Addendum No. 1

DATE: January 18, 2012

PROJECT NAME: E Bldg Classroom/Conference Room Remodel

JJC PROJECT NO.: B12004

FIRST FLOOR ELECTRICAL DEMOLITION PLAN 1
SCALE: 1/4" = 1'-0"

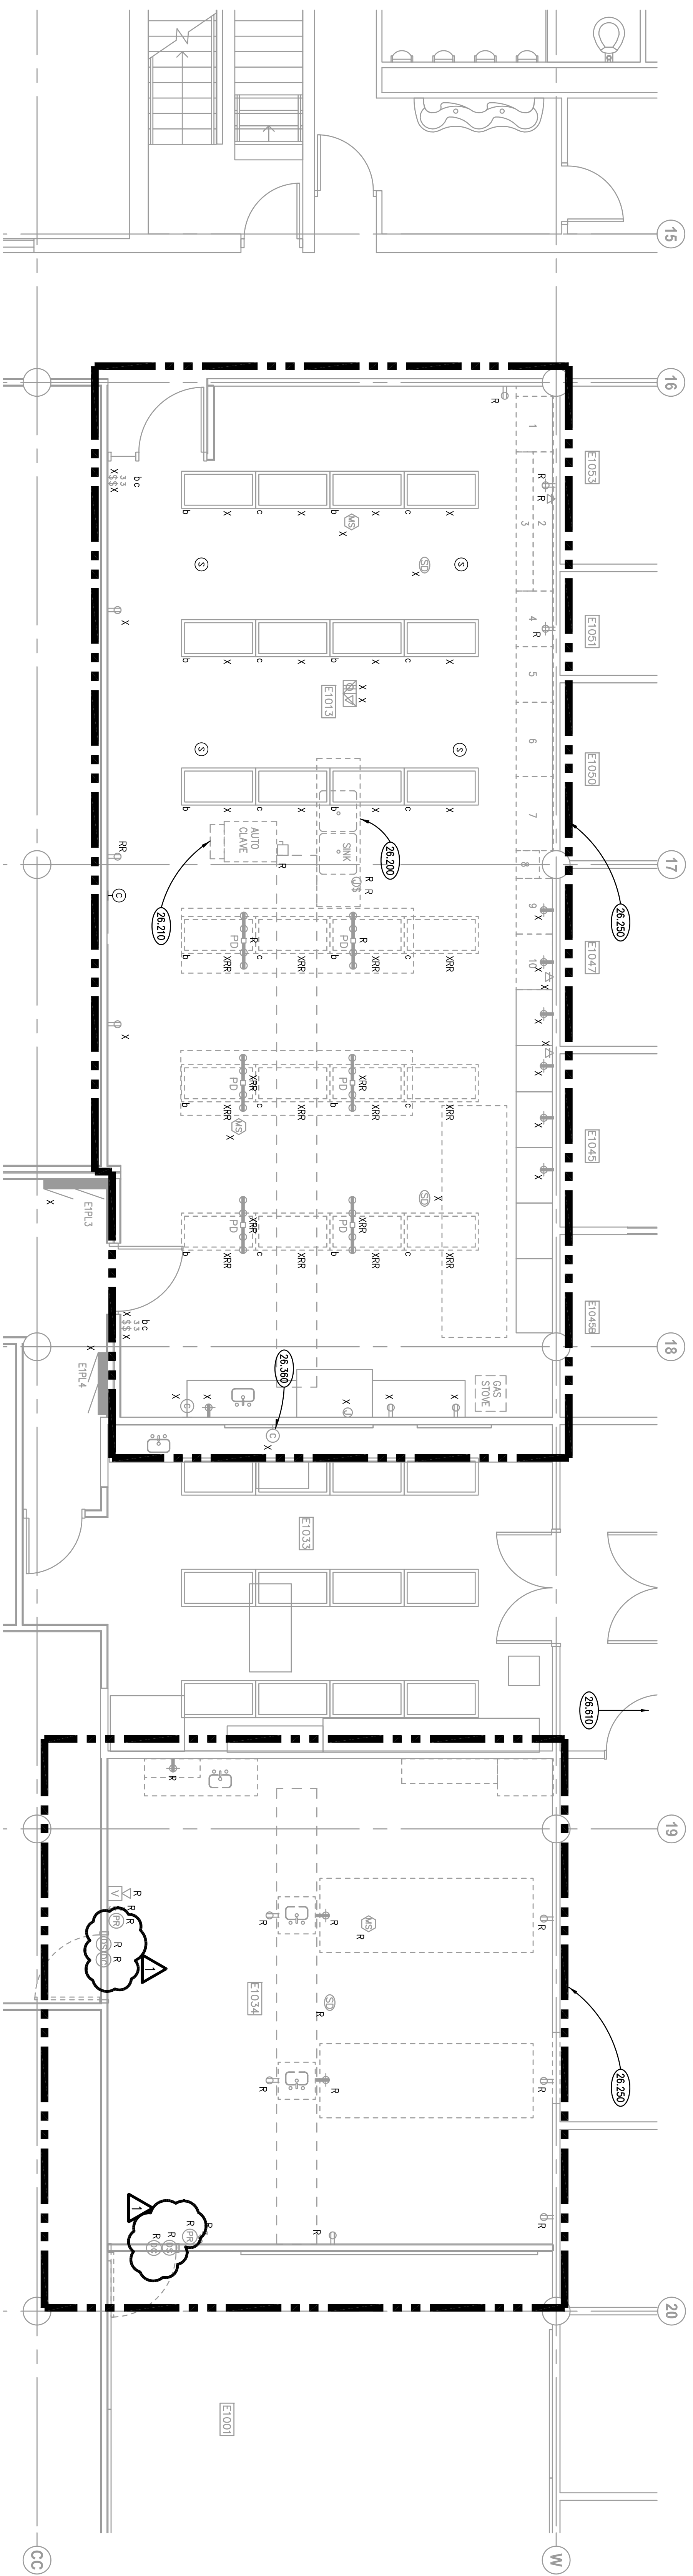
Sheet E310 – First Floor Electrical Demo., Electrical and Lighting Plans.

1. Provide the following modifications as shown (clouded) on the drawings:
 - a. Detail # 1 – First Floor Electrical Demolition Plan:
 - i. Remove existing access control devices.
 - b. Detail # 2 – First Floor Electrical and Lighting Plan:
 - i. E1010
 1. Add fire alarm horn/visual.
 - ii. E1013B
 1. Reuse existing motion sensor
 - iii. E1034A
 1. Modify fire alarm visual to horn/visual
